Re: **Solena Estate (PWS #[95738](#))  
2013 Well #1 (L112357, [YAMH56573](#)), Tank, and Secondary Treatment  
Final Approval ([PR #60-2024](#))**

**Final Approval – granted.** The project, assigned plan review # 60-2024, is granted Final Approval and the drinking water facilities may continue in service. This letter may be downloaded for future reference from our website at:

**Well Testing Water Quality Results:**

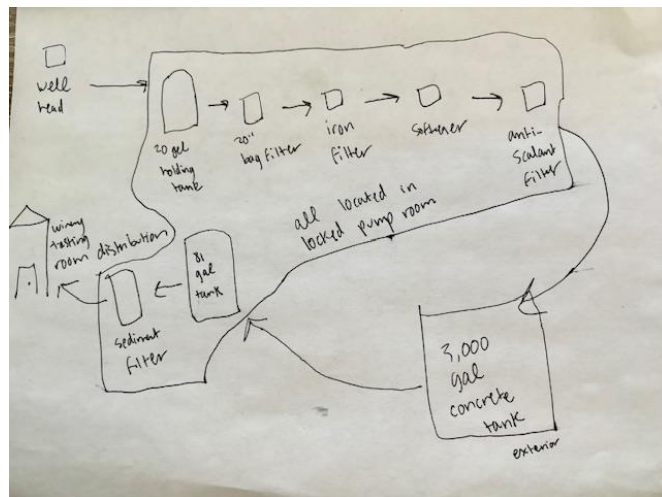
The following test results taken 4/10/24 were received on 4/18/24 and demonstrate that additional treatment is not needed to address arsenic or coliform bacteria (both not detected) or nitrate detected at 0.308 mg/l, which is less than half the Maximum Contaminant Level (EPA MCL) of 10 mg/l:

**2,000-gallon Buried Tank Photos:**

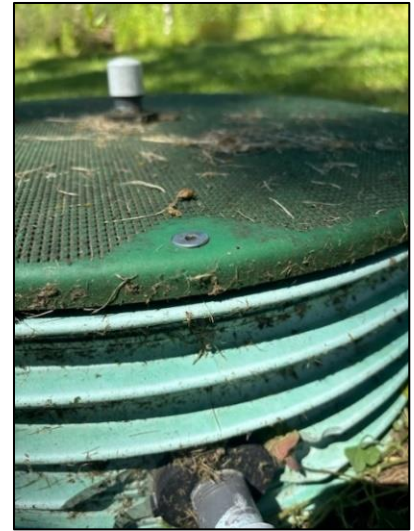
6. Concrete reservoirs shall be provided with **sufficient reinforcing** to prevent the formation of cracks, and waterstops and dowels shall be placed at construction joints. Poured-in-place wall castings shall be provided where pipes pass through the concrete.

7. Where ground-level reservoirs are located partially below ground, the **bottom shall be above the ground water table and footing drains** discharging to daylight shall be provided to carry away ground water which may accumulate around the perimeter of the structure. **The tank is set on 6” of gravel so as not to allow groundwater to seep up.**

The buried reinforced concrete tank was manufactured off-site and lowered into the ground on top of a 6” thick layer of gravel. There are no penetrations made in the concrete. All pipes in and out of the tank go through bulkhead fittings installed in the riser. The access hatch on top of the tank that has a curbed watertight cover. There is a vent on the top that allows air in and out of the tank, which would also serve as the overflow should the float switches malfunction.

**These concrete tanks are manufactured with a lot of rebar and are very well built. There are no penetrations made in the concrete. All pipes in and out of the tank go through bulkhead fittings installed in the riser. Attached is a one page spec sheet for the concrete tank. The concrete reservoir was constructed off site and lowered into ground here.**

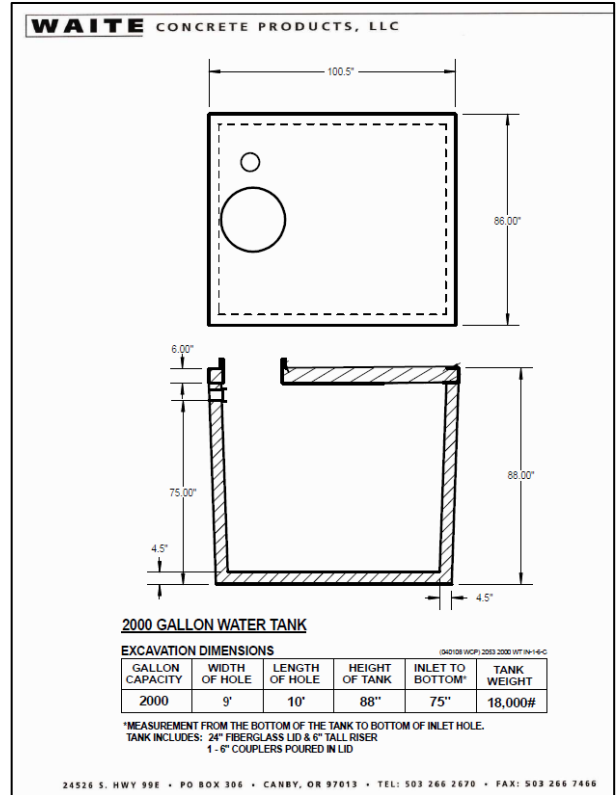
16. Where the system facilities and the premises being served are both on the same parcel of property, requirements relating to pipe materials and pipe installation shall comply with the local and/or State **Plumbing Code**.

**See attached occupancy letter from the county of Yamhill. They inspected all plumbing and permits, and occupancy would not be granted if we were not in compliance with code.**
